Change Application to PDA Approval for Precinct 15 (Part) of Aura at Lot 10 Bells Creek Road, Banya (EDQ Reference: DEV2023/1445)

1 Introduction

3 Overview of Proposed Changes

Figure 1 – Relocated Retail Entry (Site Access)

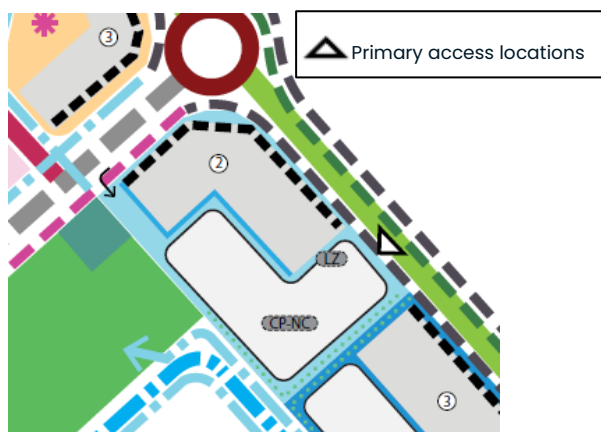
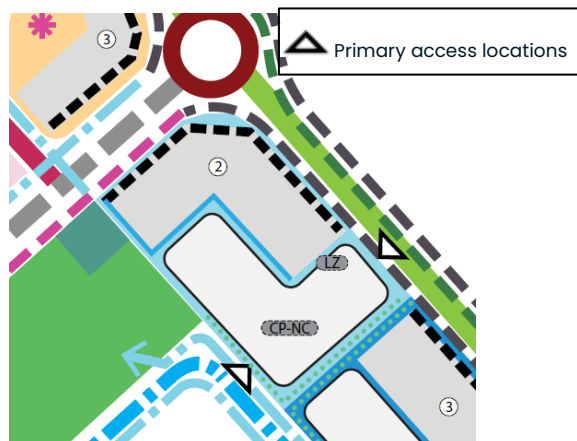
The approved Plan of Development currently locates the entry to the Neighbourhood Centre (Lot 8102) at the north-western and eastern boundaries of the site, as shown in **Picture 1** of **Figure 1** below.

Given the Neighbourhood Centre is a high traffic generating land use, a revised access arrangement is proposed to include an additional entry from Access Street Urban D at the rear of the site. This will distribute traffic more effectively, with a significant proportion of vehicle trips expected to utilise the approved eastern access, as illustrated in **Picture 2**.

In addition to the introduction of the rear access point, it is proposed to remove the previously approved left-in access located on the northern road frontage (refer to **Figure 1** above). The road layout delivered in this location includes a median crossing and pedestrian refuge that provides an important safety and connectivity function for local pedestrians. Refer to **Figure 2**.

Figure 3 – PoD Comparison of Neighbourhood Centre Access Arrangements

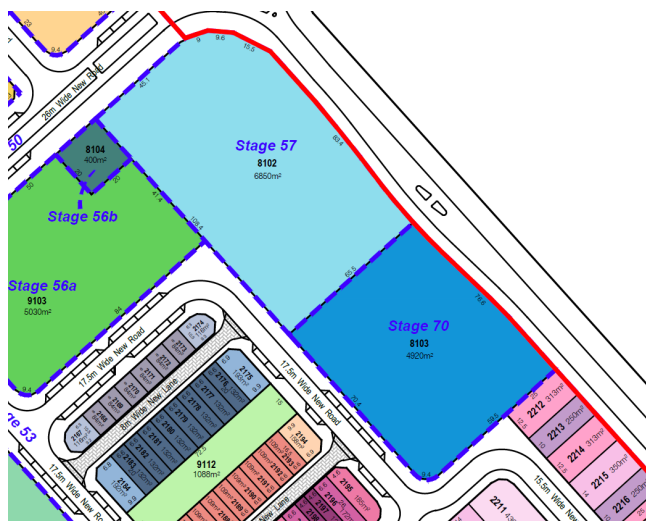
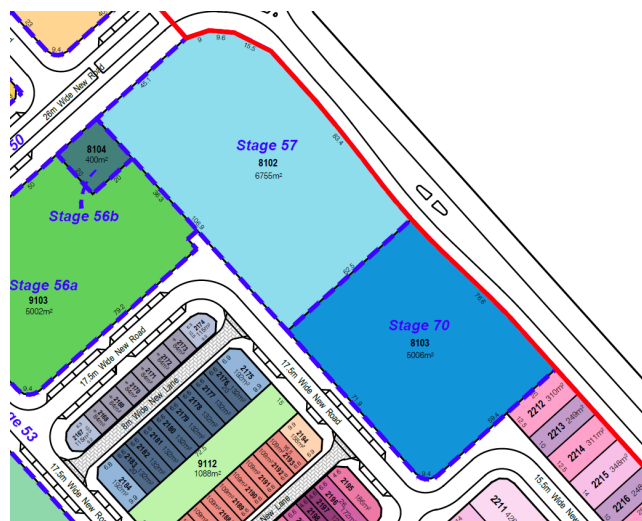
A review of the approved Plan of Development identified that previous amendments to the Precinct 15 (West) approval inadvertently reduced the area of the Community Facilities Lot (Lot 8103) to below the minimum 0.5 hectare requirement established under the relevant Infrastructure Agreement.

To rectify this issue, a minor adjustment is proposed to the shared boundary between the Neighbourhood Centre Lot (Lot 8102) and the Community Facilities Lot (Lot 8103). Specifically, the common boundary has been shifted approximately 1.35m north-west, resulting in an increase to the area of Lot 8103 and ensuring compliance with the minimum lot size requirement.

Figure 4 – Proposed Built Form Control (Table 10) and PoD Annotation

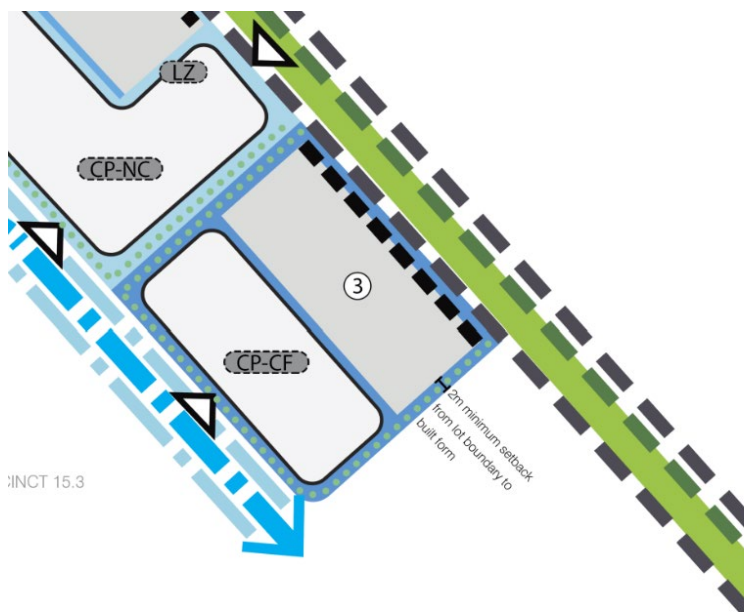
An updated Bushfire Hazard Assessment and Bushfire Attack Level (BAL) Plan has been prepared by Covey and is included as **Attachment E**. The assessment has identified that a minimum 2 metre setback is required along the south-eastern boundary of the Community Facilities Lot (Lot 8103) to achieve the appropriate bushfire management outcomes.

In addition, corresponding annotations have been incorporated into the amended Plan of Development to clearly identify the extent of the required setback area.

"The minimum setback between the south-eastern boundary of Lot 8103 (Community Facilities Lot) and the outermost projection of any building or structure is to be 2 metres, for bushfire management purposes."

Figure 5 – Lots Affected by BAL

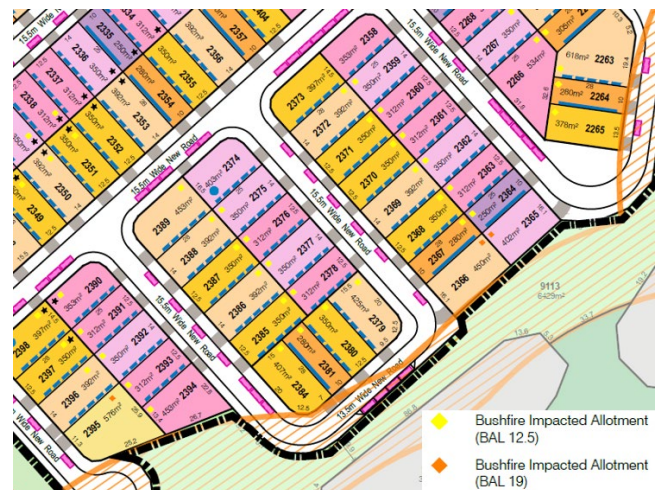
In response to this requirement, a Bushfire Hazard Assessment and BAL Plan has been prepared by Covey and is provided as **Attachment E**. The assessment demonstrates compliance with the relevant bushfire management standards and provides indicative BAL ratings to inform the development layout and design considerations across the development area.

All remaining lots are identified as either being greater than 100 metres from bushfire prone vegetation or not applicable. The report also confirms that all lots within the development are capable of achieving BAL 29 or lower. **It is therefore requested that Condition 37 be deleted and replaced with standard conditions** requiring compliance with the relevant BAL ratings shown within the BAL Assessment. As the revised design now satisfies this requirement, the existing condition is no longer necessary.

Figure 6 – Proposed Urban Warehouse Allotment Changes

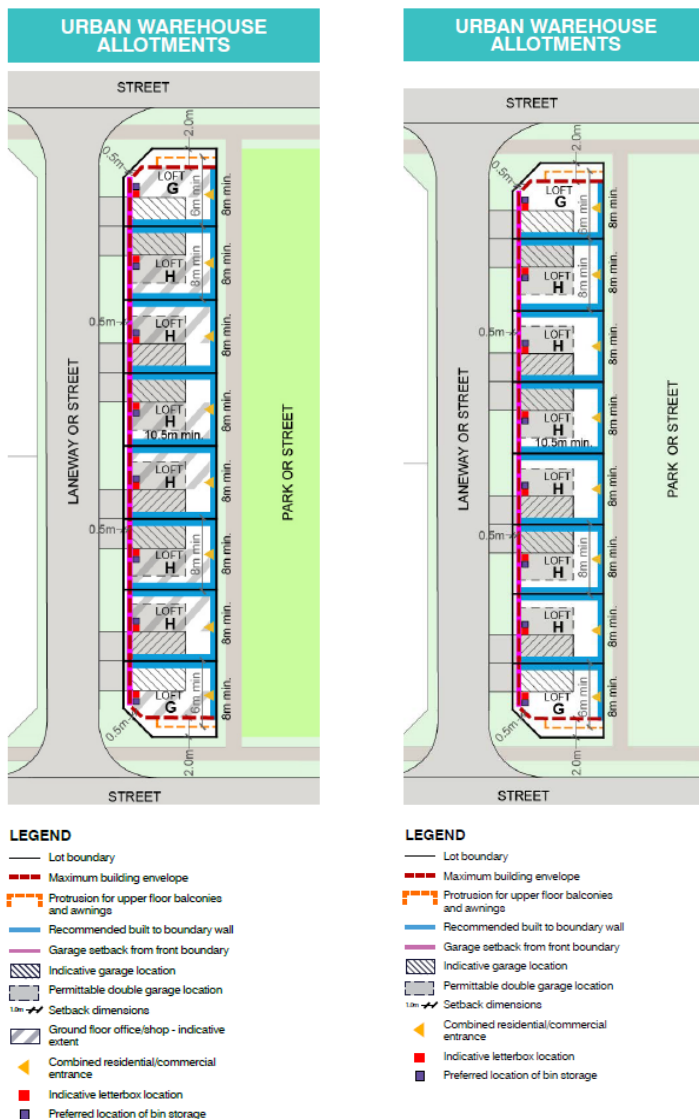
The approved Plan of Development currently identifies Lots 2167 to 2174 (Urban Warehouse Allotments Type G and H) as being capable of accommodating a ground floor office or shop use as an "as of right" outcome.

Following further consideration of the intended development outcomes for this portion of the precinct, it is proposed to remove this provision and associated notation from the Plan of Development. This change is reflected through the removal of the relevant hatching and annotations applying to Lots 2167 to 2174.

Figure 7 – Proposed Easement Alignment

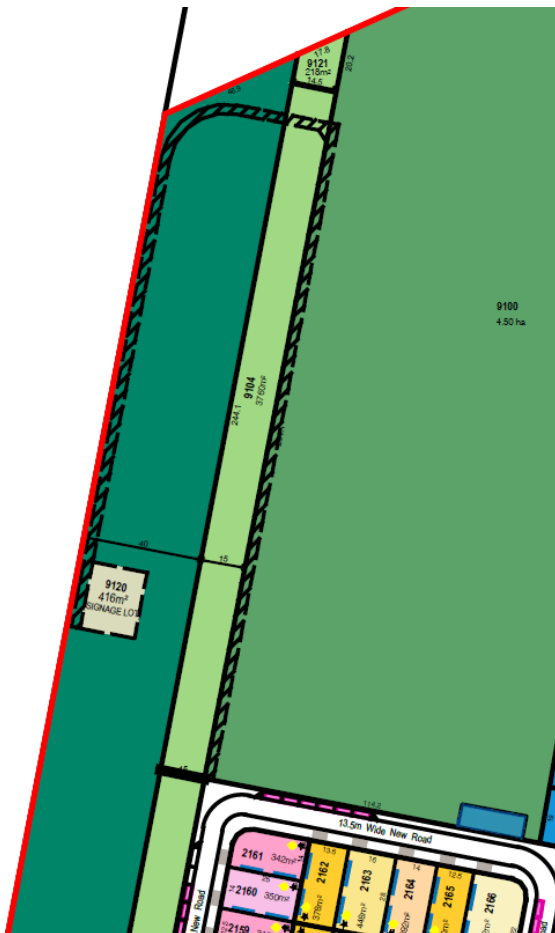
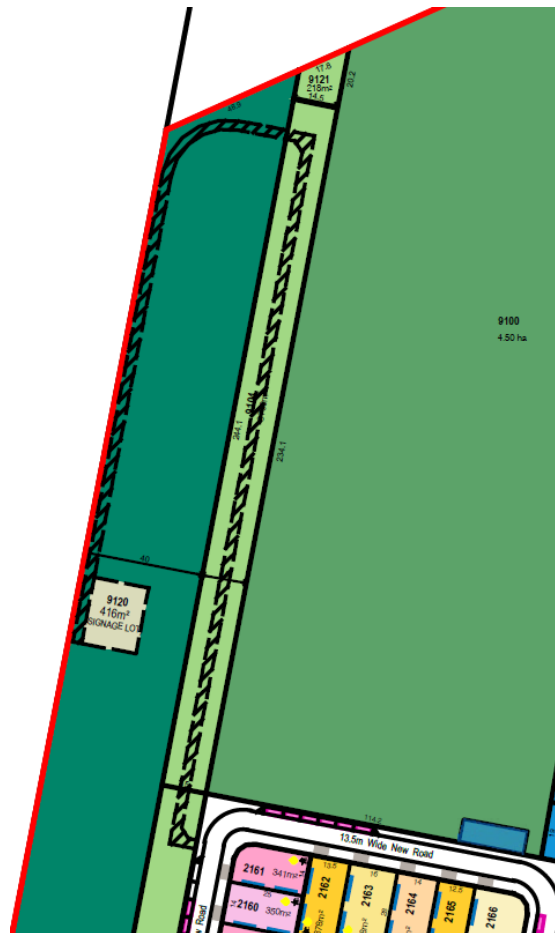
Since approval of this arrangement, Stockland has undertaken a further review of the access requirements and considers the revised alignment to be unnecessarily duplicative. The approved alignment would effectively require construction of a dedicated vehicle access route immediately adjacent to a pathway that is already capable of accommodating the limited maintenance access required for the signage lot.

Importantly, maintenance access is anticipated to occur only infrequently and would be undertaken by a standard tray-back utility vehicle rather than heavy maintenance machinery. Given the scale and frequency of these movements, it is not considered that use of this pathway would result in adverse impacts to the structural integrity or ongoing operation of the linear park infrastructure.

Accordingly, the Applicant seeks to revert the access easement alignment to the previously approved alignment within the linear park corridor. This approach avoids unnecessary duplication of infrastructure, reduces disturbance within the Neighbourhood Sports Park and provides a more efficient and practical maintenance outcome whilst maintaining access to the signage lot.
